Structural Review

Refer to Existing Plans and Exterior Elevations marked up with our site observations following this narrative, along with our preliminary chapter 34 evaluation information. Text in bold represents our recommended scope of work.

Exterior Elevation Notes: Emery Grover Building, Needham, MA

EXISTING
ATTIC PLAN
1/8" = 1'-0" ±

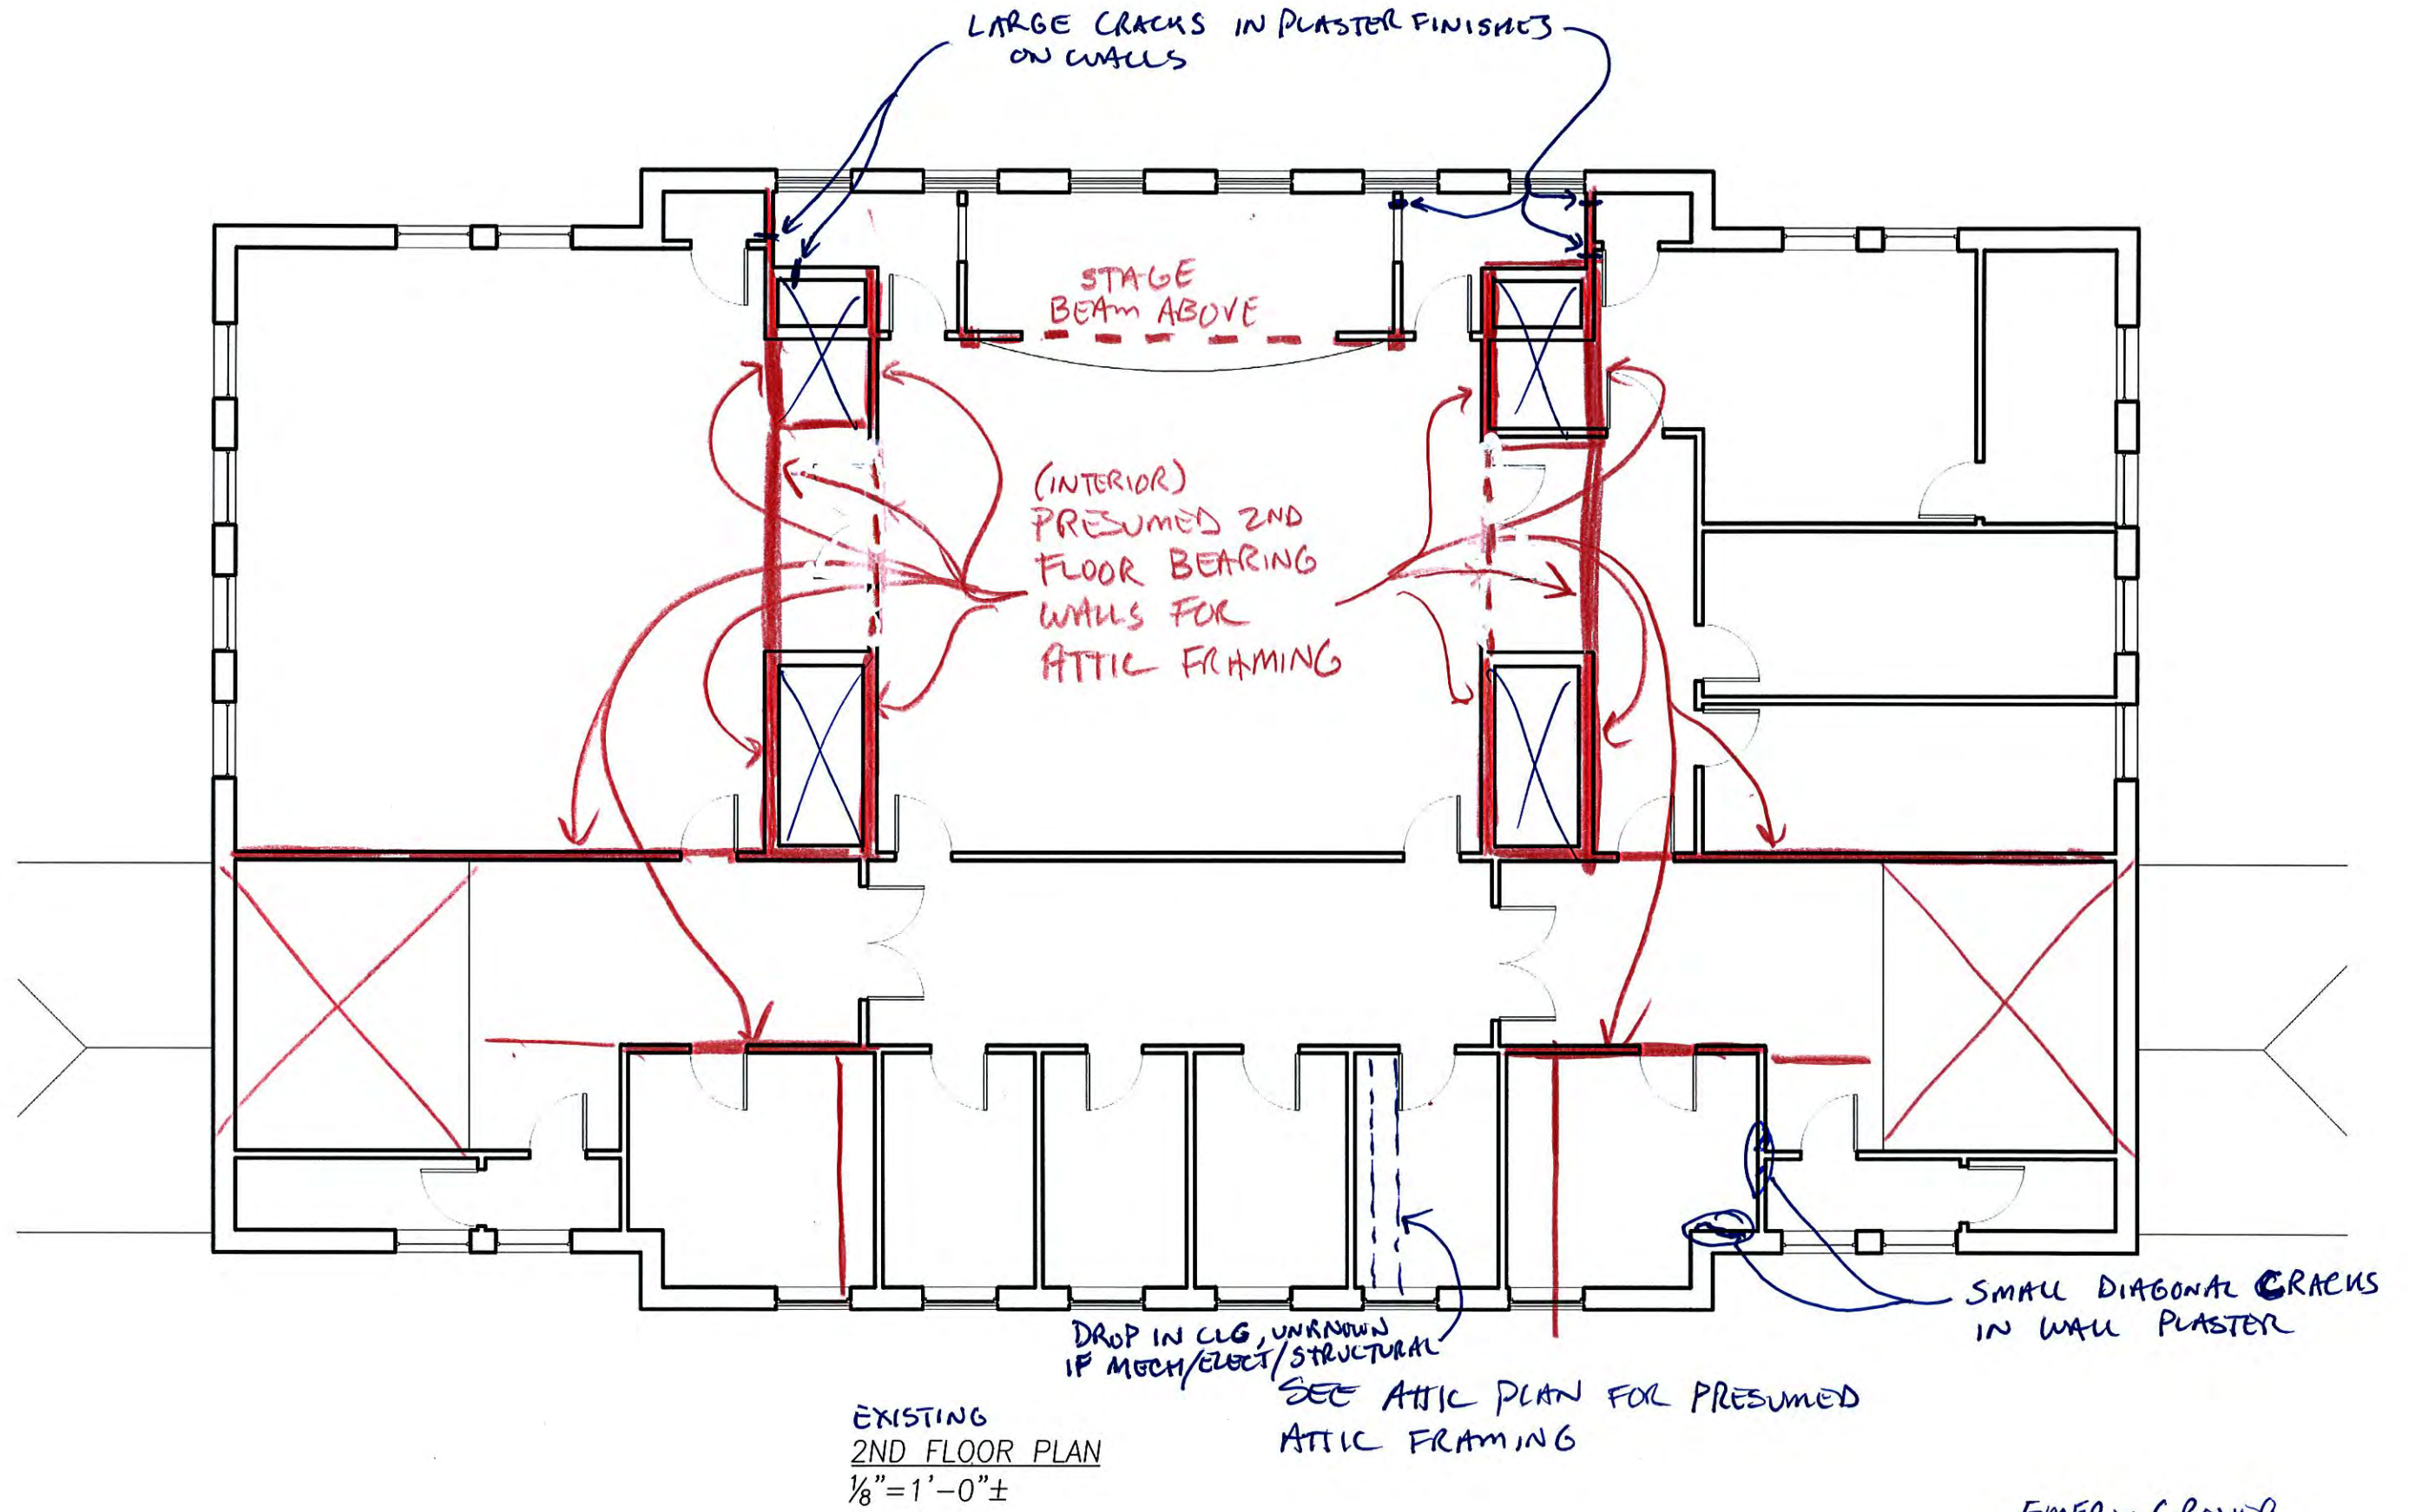
Not all attic framing was visible during Structures North's site visit. Joists and beams that we were able to observe typically had mortise and tenon connections when supported by other wood beams. The tenons were relatively small, likely only one or two inches tall. At several locations, horizontal splits in the supported framing were observed originating at an edge of tenon and extending several feet along the length of the member. Joists often had a small (1/4" to 3/8"+/-) gap between their ends and the supported member. Light gage metal joist and beam hangers, such as Simpson face mount hangers, should be installed throughout the building (all floors) at mortise and tenon connections.

The two trusses, which are the full height of the attic to roof space, and which appear to clear span the building in the east-west direction, would need further evaluation. We suspect that under a modern code analysis they would be considered overstressed and either need reinforcing or additional framing systems added to lessen the load the trusses take. **Given the general open space layouts of the proposed rooms below the trusses, we suspect the more expensive truss reinforcing option would be required to prevent new framing from interfering with the occupancies below.**

Our preliminary calculations indicate that at the center of the building, where attic joists span approximately 18.5 feet, they have an approximately 60psf live load capacity, which would be suitable for offices (without partitions), or residential occupancy. At the south and north ends of the buildings, where the spans are approximately 22 feet, the joists have only an approximately 30psf live load capacity, which is not suitable for occupancy. **We would anticipate that in order to use the attic, ALL joists would need to be sistered, and/or new beams and columns introduced to shorten existing joist spans.**

CRACKS IN PLASTER
@ UNDERSIDE OF
ROOF

EXISTING
2ND FLOOR PLAN
1/8" = 1'-0" ±

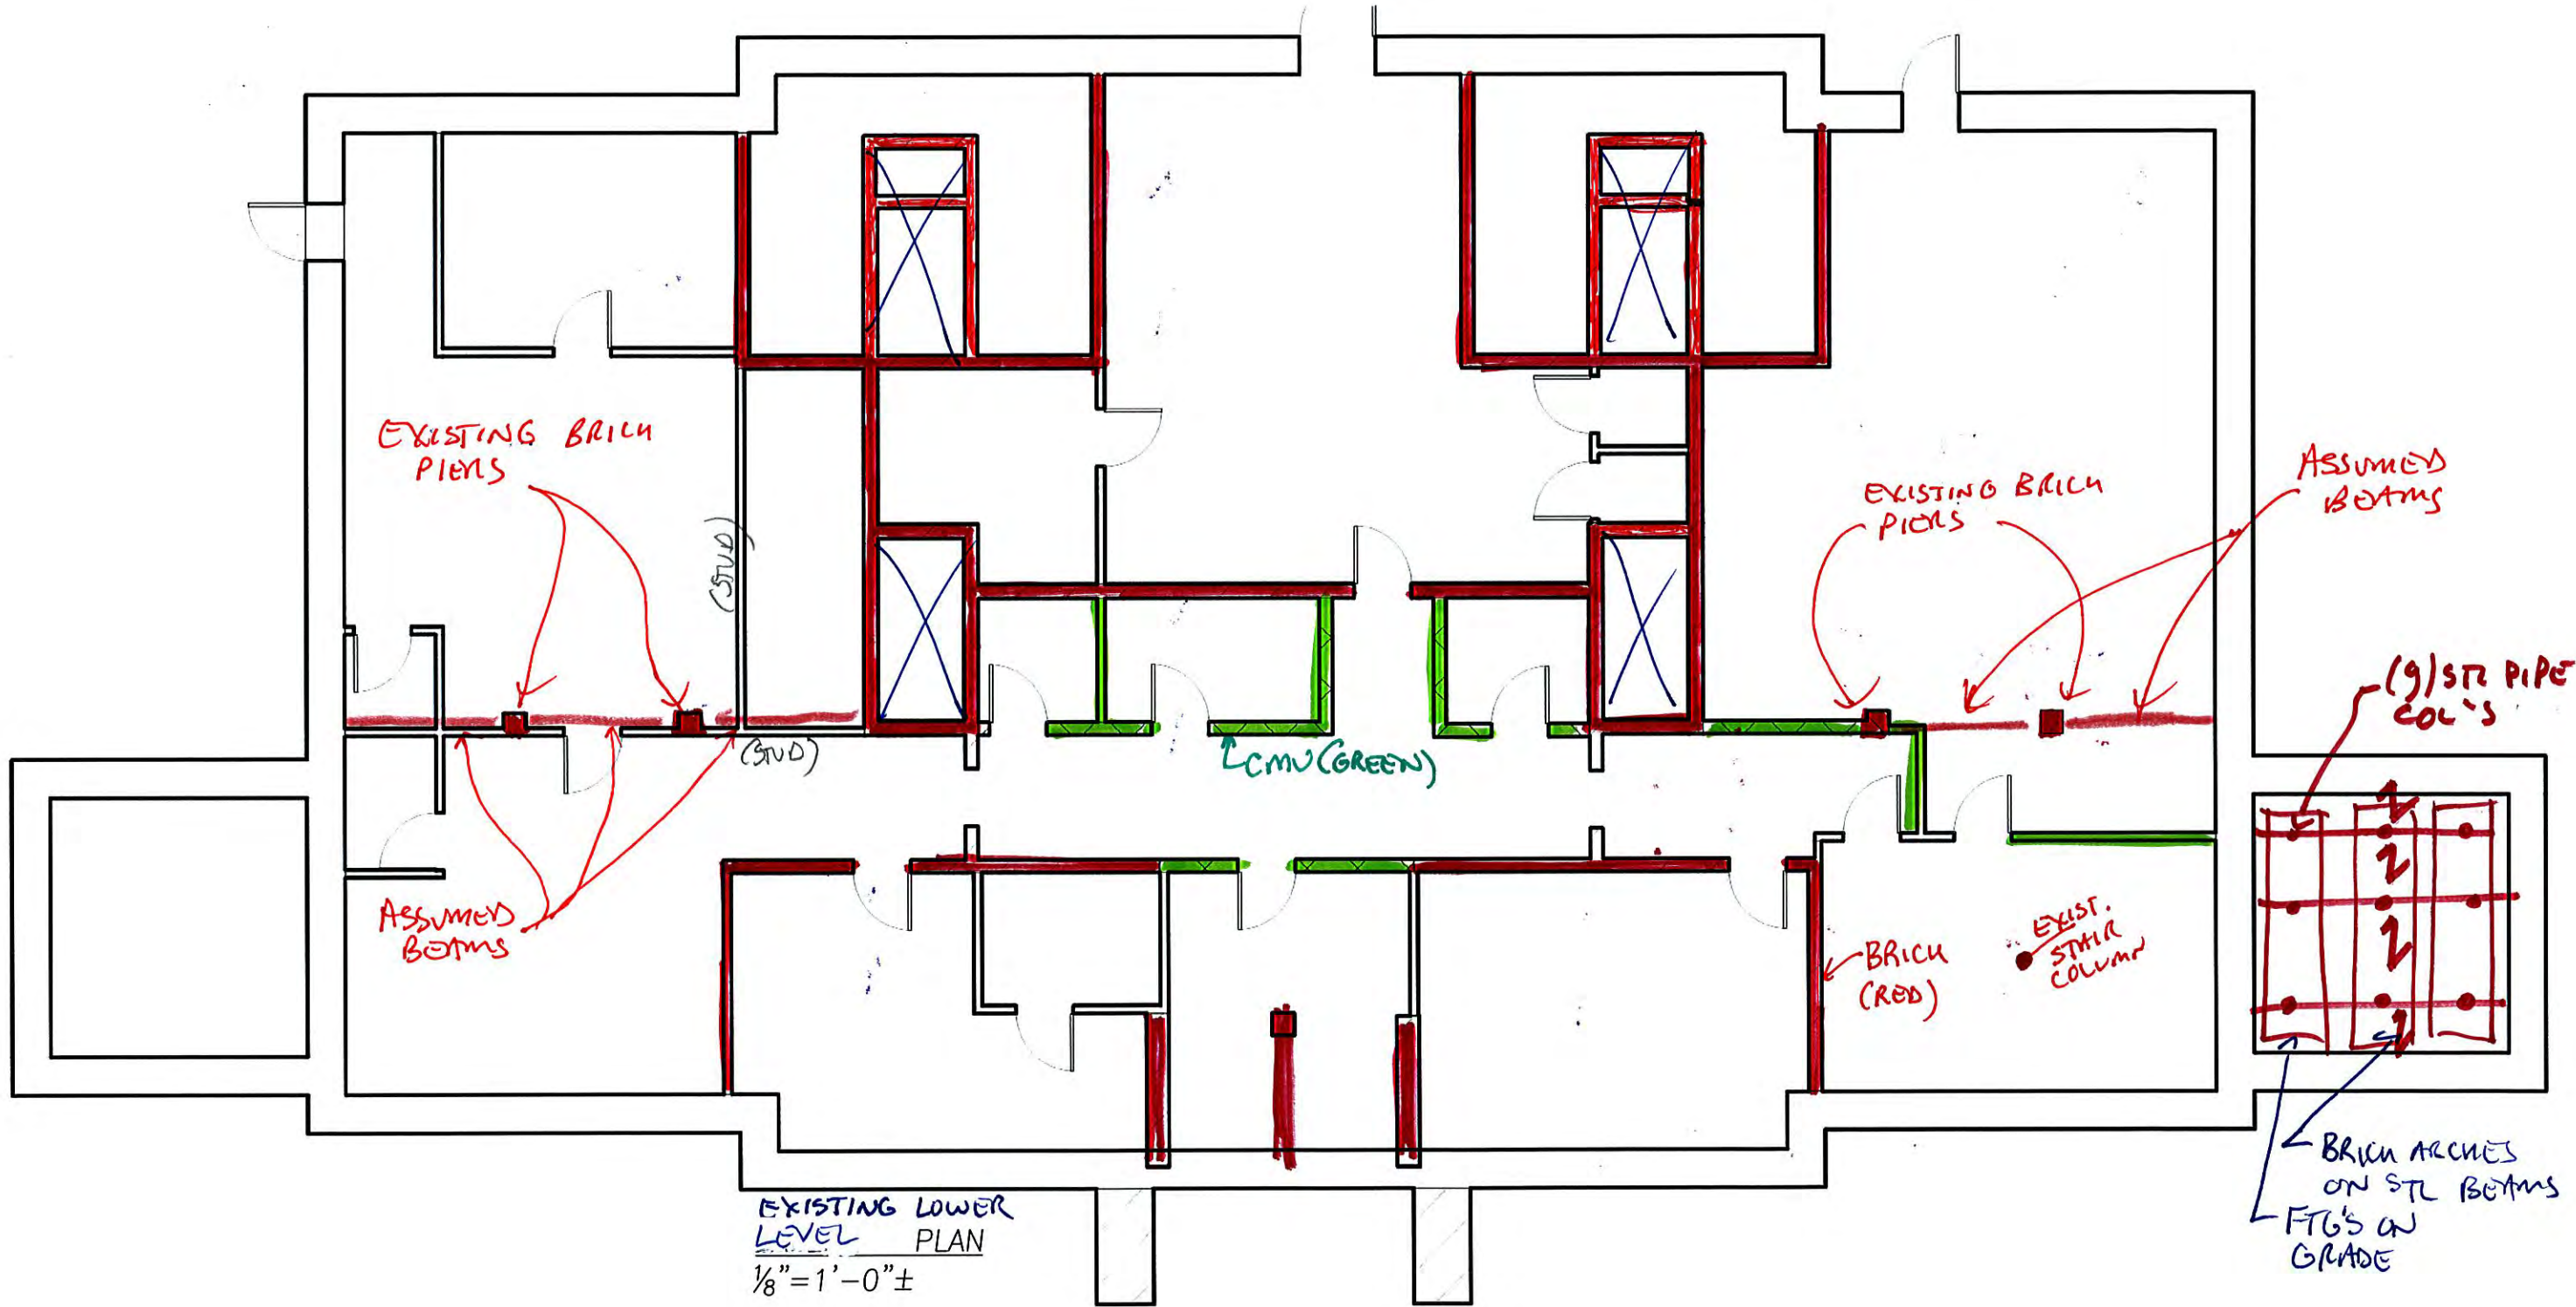
Wall, floor, and ceiling surfaces were typically covered with finishes, obscuring framing, during our site visit. There were some walls that appeared to have older (original) plaster finishes that were cracked, as noted on the plans. These walls may need further investigation once finishes are removed. It is uncertain at this point if the cracks were caused by foundation settlement, temperature and moisture shrink/swell effects, or by other causes.

We would expect that the walls noted as presumed bearing walls on the attached plans would remain. Further investigation will be required once interior finishes are removed, but **any bearing wall removal would require new post and beam replacement framing.** Some of these walls, notably the masonry shaft/chimney walls, might be shear walls. We would expect shear walls to remain, but if any are removed, new lateral load resisting systems would need to be installed in alternative locations, especially in the east-west direction. Given the rigidity of the existing masonry shear walls (including exterior walls), **any replacement lateral load resisting systems would ideally be masonry also.** Using steel braced frames or moment frames would likely be cost prohibitive and/or structurally inefficient due to their lesser rigidity than masonry shear walls. Replacement masonry shear walls would need to stack from floor to floor.

Existing framing is unknown because none of the second floor framing was visited during site visit. Based on our assumed bearing wall locations (see attached plans), we are anticipating joists have up to 26 foot spans. Joist sizes and spacing are unknown, but we would expect to see something on the order of 2x12's at 12" o.c. Joists this size and spacing would be more than 100% overstressed under a 100psf assembly live load for a 26 foot span, and would deflect 2.8 inches. This deflection is much more than what we generally consider tolerable. Unless existing beams were found to shorten joists spans, we **would expect the need for new lines of steel beams and columns, down to new footings in the basement, to be required to shorten the joist spans. New footings would require the involvement of a geotechnical engineer's services.** Even if existing beams were found, our experience has been that beams in building this age often are undersized based on modern building code requirements, and they would likely need strengthening or replacement. It was noted that the central space was originally used as an auditorium that served 275+/- people. Based on our limited observations, we would not expect it to allow for use as assembly space without significant reinforcing.

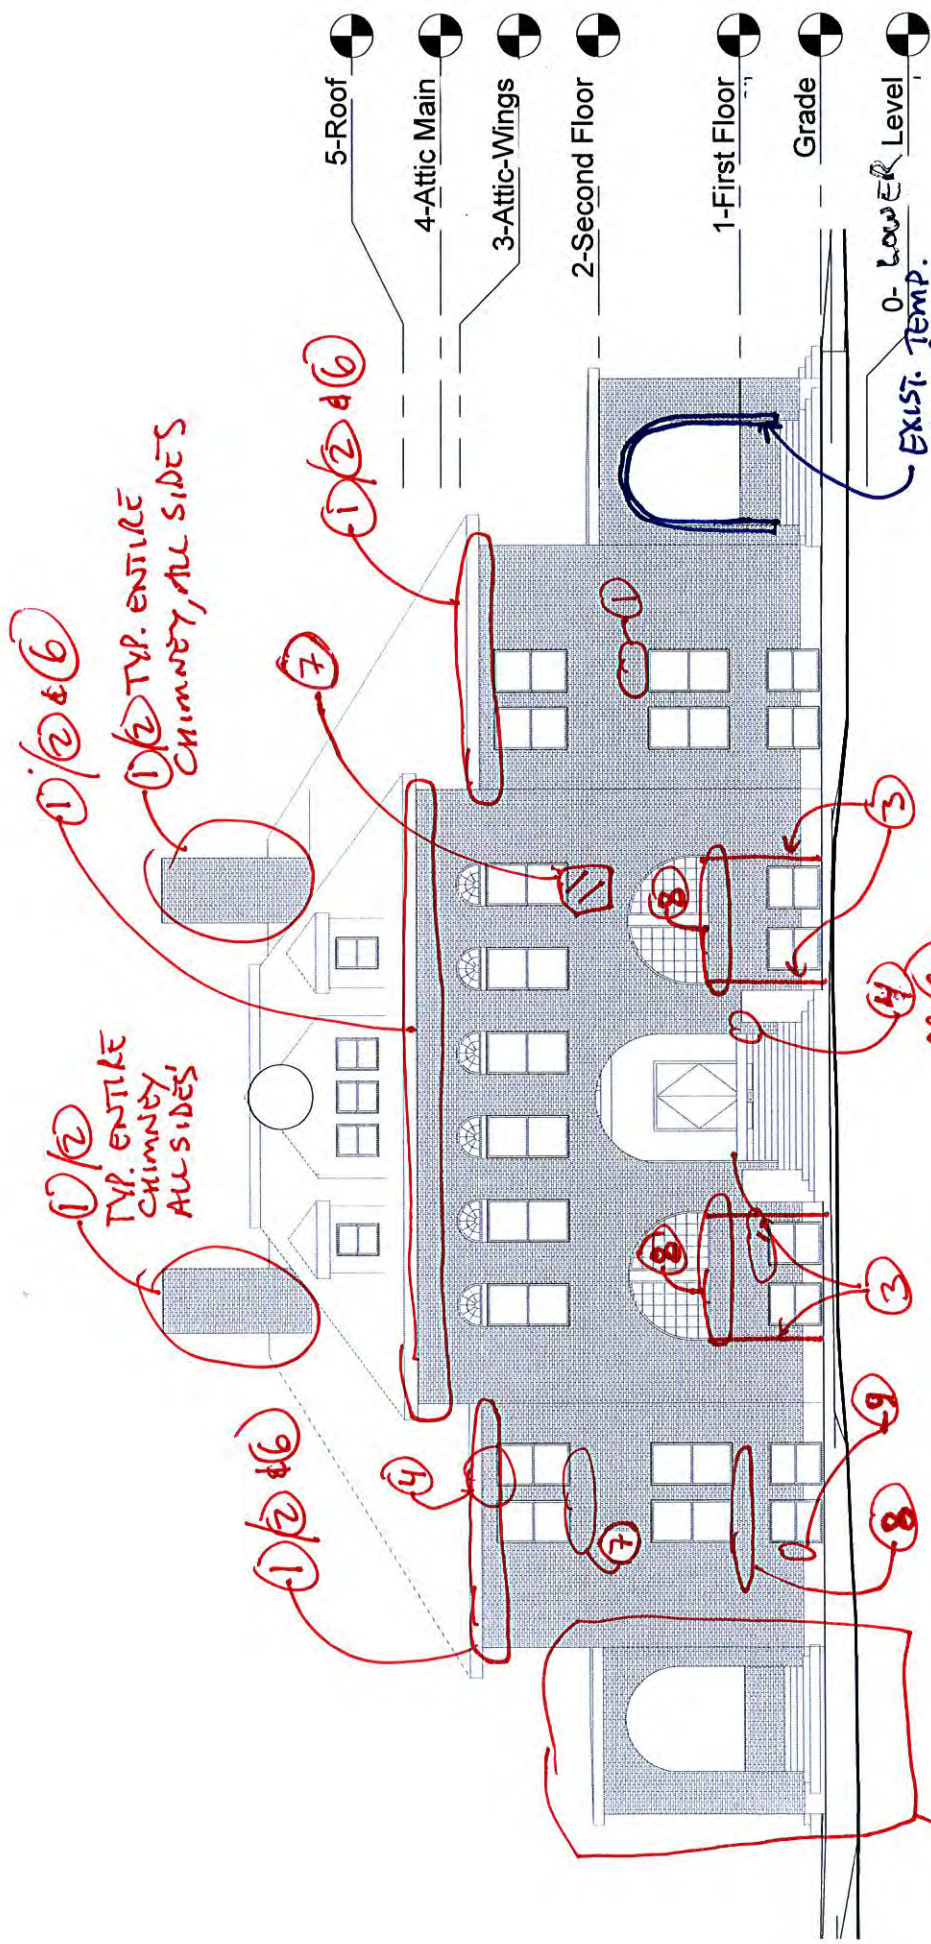
ALL ELEVATIONS: Investigate existing connection of veneer to backup. Smaller dimensions of veneer brick, combined with likely larger brick dimensions for backup brick, likely resulted in infrequent connection between veneer and backup. Assume pinning of veneer to backup will be required.

- ① Repoint.
- ② Re-set or pin loose or shifted bricks or stone sill.
- ③ Caulk joints.
- ④ Reset, replace, and/or stitch brickwork at cracks or damaged bricks.

- ⑤ Possible localized bow or bulge in wall. Will require further investigation into cause. Assume pinning, brick resetting, and re-detailing of connection of interior framing to exterior wall. A lift inspection should be performed and the masonry sounded out with a hammer.

- ⑥ Further investigation is required to determine whether roof thrust loads or rusting embedded metals are causing brick movement.
- ⑦ Consider flashing under the brick soldier course. Reset bricks. (Water is soaking into joints, combined with no brick weight above this level at windows but brick weight from above on adjacent bricks, causing bricks at this location to bow upward).

- ⑧ Pull bricks out and perform a deep re-packing and resetting of bricks. (Issue with brick that readily absorbs water and swells, in combination with a lack of window drip, in contact with stone sill that does not readily absorb water).

- ⑨ Mortar repair cracks. (Issue of brick moisture growth/swelling alongside a stone foundation that does not expand, leading to friction in the joint between the two differing materials).

①/② & ⑥
 ①/② TYP. ENTIRE CHIMNEY, ALL SIDES
